CAP MEETING – 10 NOVEMBER 2021
ITEM 9.2

DEVELOPMENT NO.:	21019844
APPLICANT:	Bird in Hand Winery
ADDRESS:	150 PFEIFFER RD WOODSIDE SA 5244
NATURE OF DEVELOPMENT:	Variation to 18/828/473 to increase the floor area and the height of the cellar door, restaurant & function facility and internal alteration
ZONING INFORMATION:	Zones: <ul style="list-style-type: none"> • Productive Rural Landscape Overlays: <ul style="list-style-type: none"> • Environment and Food Production Area • Hazards (Bushfire - Medium Risk) • Heritage Adjacency • Hazards (Flooding - Evidence Required) • Limited Land Division • Mount Lofty Ranges Water Supply Catchment (Area 2) • Native Vegetation • Prescribed Water Resources Area • Water Resources
LODGEMENT DATE:	29 Jul 2021
RELEVANT AUTHORITY:	Assessment Panel at Adelaide Hills Council
PLANNING & DESIGN CODE VERSION:	2021.10
CATEGORY OF DEVELOPMENT:	Code Assessed - Performance Assessed
NOTIFICATION:	Yes
RECOMMENDING OFFICER:	Doug Samardzija Statutory Planner

- Increase the height of the building from 15.24m to 18m, an increase in height by 2.76m
- Increase the floor area by 150m², which includes a combined increase in the ground floor and first floor areas

BASEMENT/CELLAR PLAN 1:100

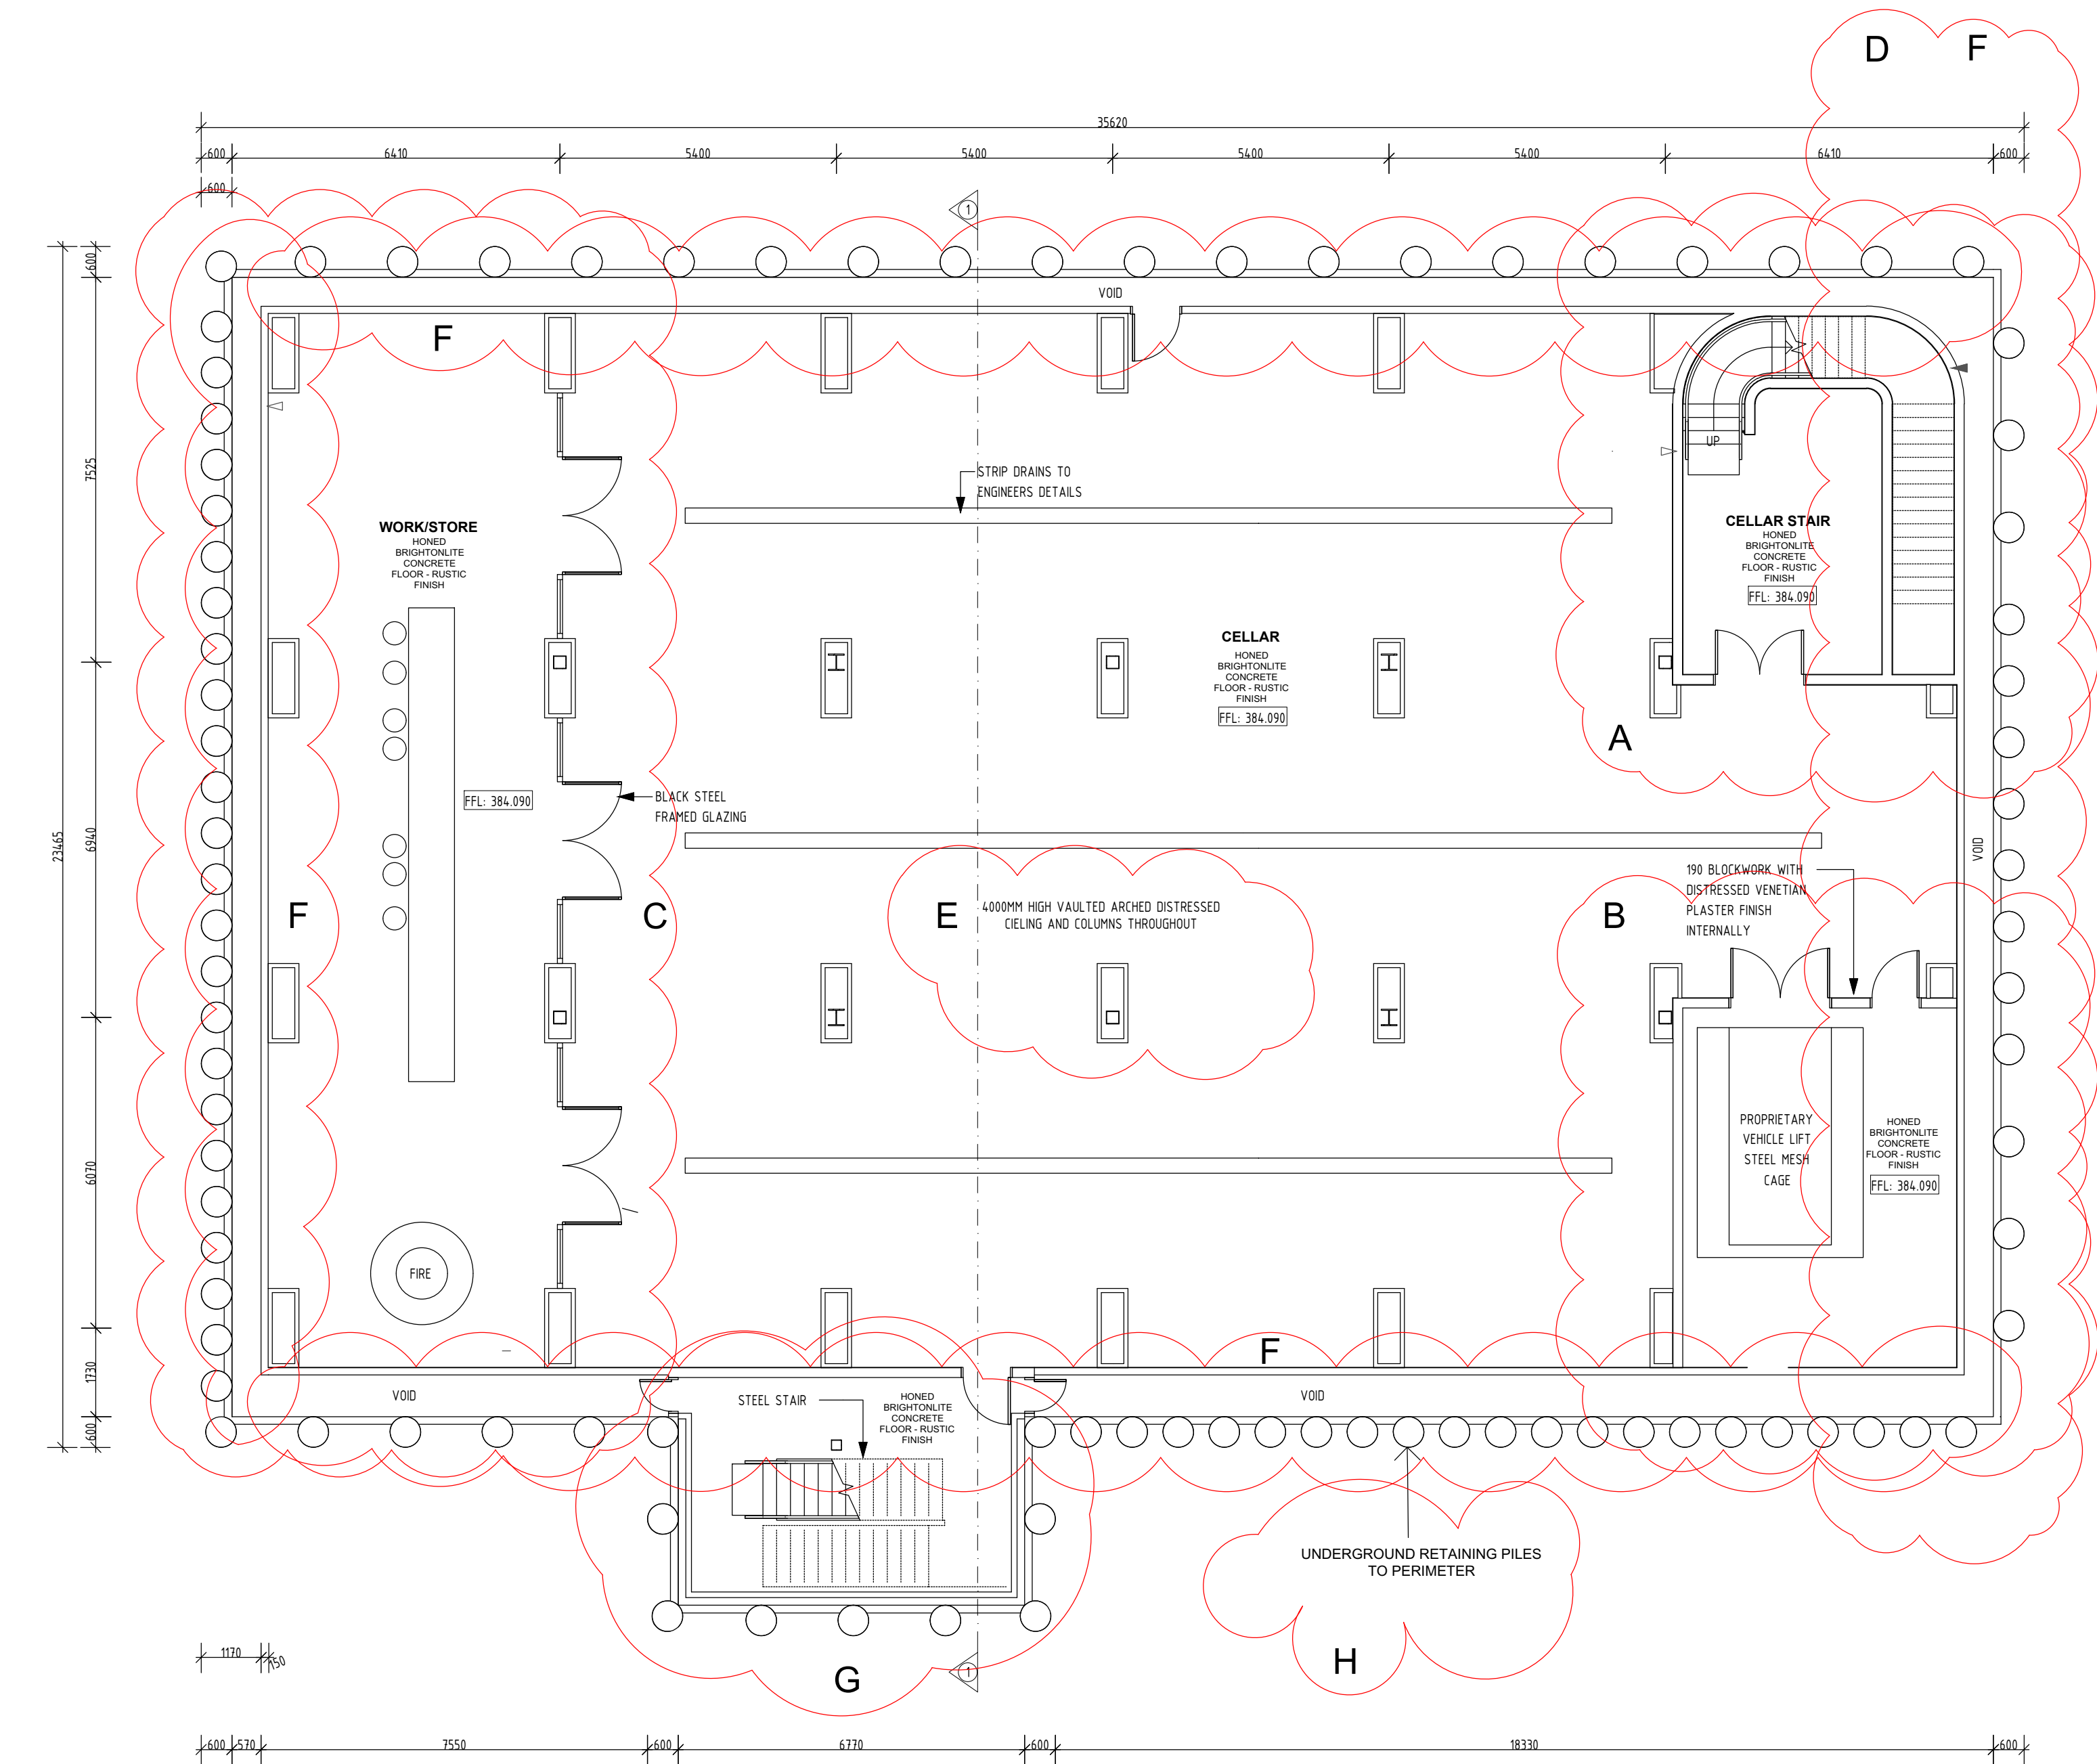
REVISION LIST	
The Basement/Cellar	
(a)	location of the "everyday access stair" moved to north eastern corner (no personal lift access to this level);
(b)	vehicle lift added;

(f)	internal void cavity double wall space created to aid in waterproofing and ventilation;
(g)	fire stair added to southern wall;
(h)	underground retaining pile structure noted;
The Ground Floor/Barrel Hall/Tasting room

drawing FIRST FLOOR/GALLERY PLAN

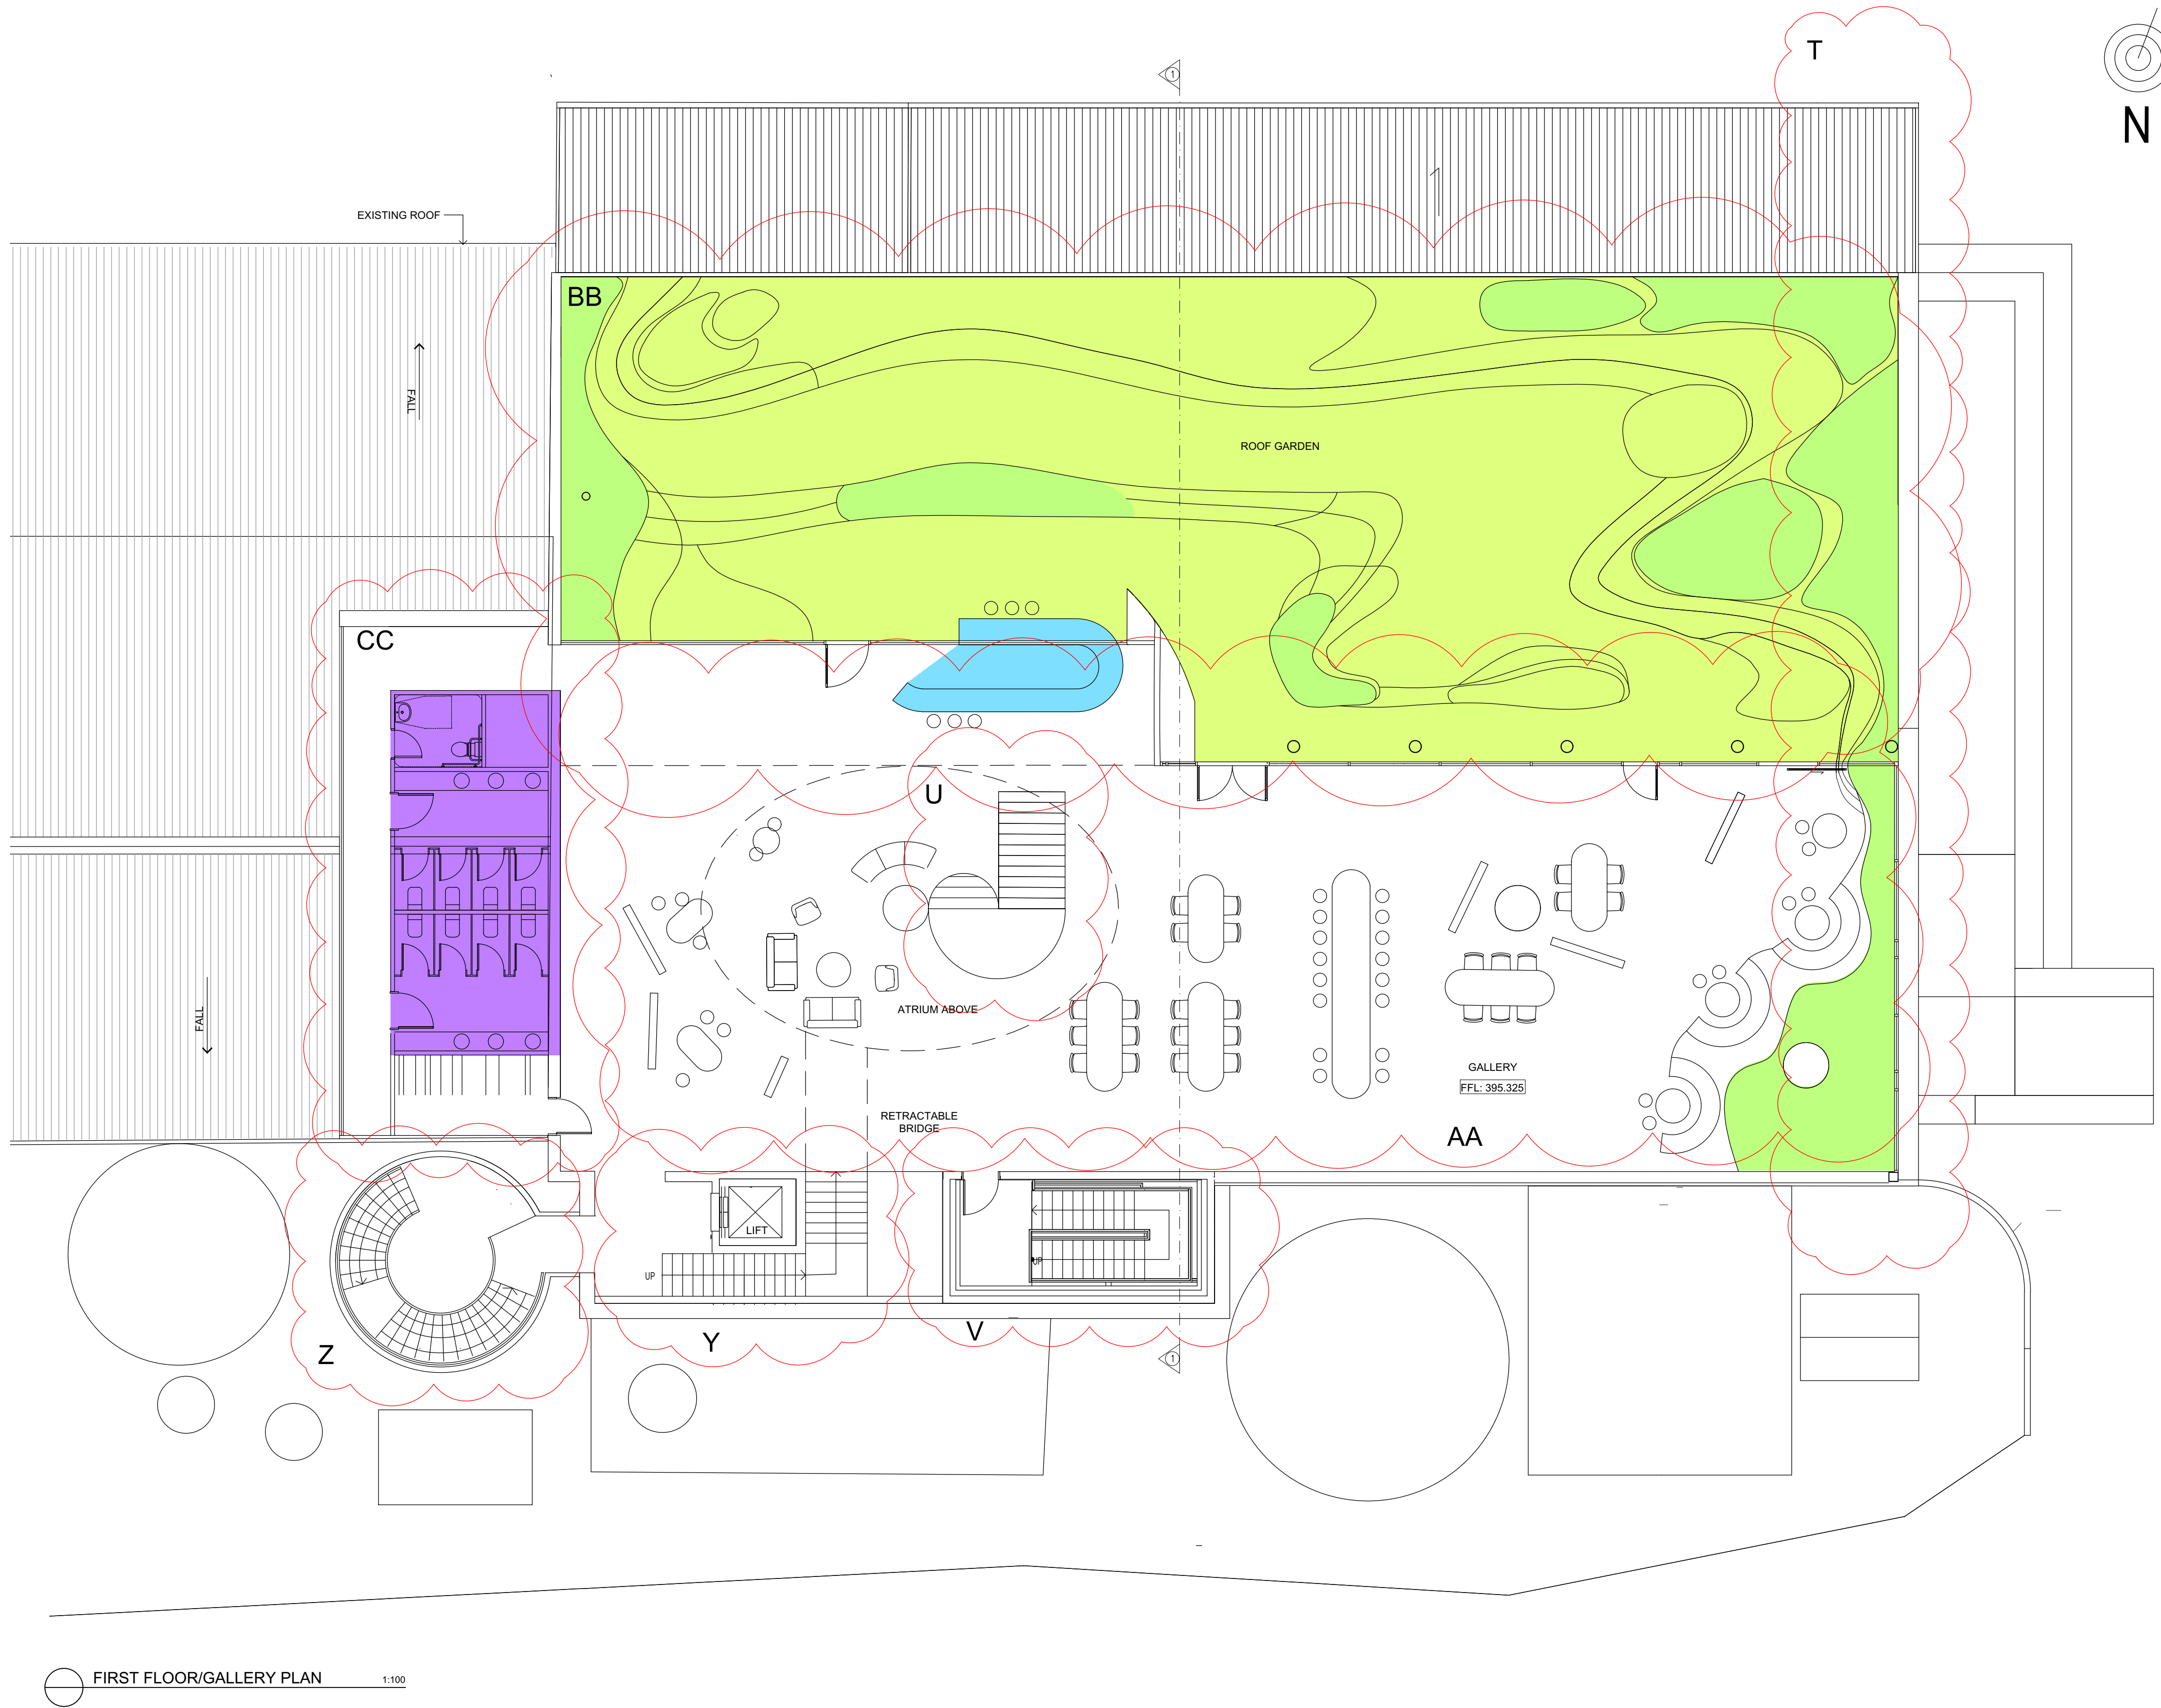
- (k) the eastern side of the barrel hall feature door increased in height and external steps and ramp reconfigured to suit;
- (l) vehicle lift added;
- (m) location of the everyday access stair position changed;

- (n) fire stair added to southern wall;
- (o) passenger lift relocated to southern wall;
- (p) stair case added into existing silo up to first floor;
- (q) barrel hall ceiling height increased, resulting in barrel hall north and south parapet walls increasing in height by 2575 mm;

- (r) new French timber louvred shutters added into the northern parapet wall (to create some articulation and also enable ventilation down into cellar);

- (t) length of the floor level increased in length in an easterly direction by 3145 mm;
- (u) location of the everyday access stair position changed;
- (v) fire stair added to southern wall;
- (w) overall roof height increased to RL 406.835;
- (x) southern wall is to be rendered to match the existing wall;
- (y) stair case up to mezzanine floor relocated to the on southern wall with curving roof above;
- (z) stair case added into existing silo;
- (aa) internal layout changed;
- (bb) roof garden is flat and stepped rather than sloping;
- (cc) toilet block has moved into existing shed roof space;
- (dd) balustrade has changed from frameless glass to steel flat plate verticals; and
- (ee) altered changed location.
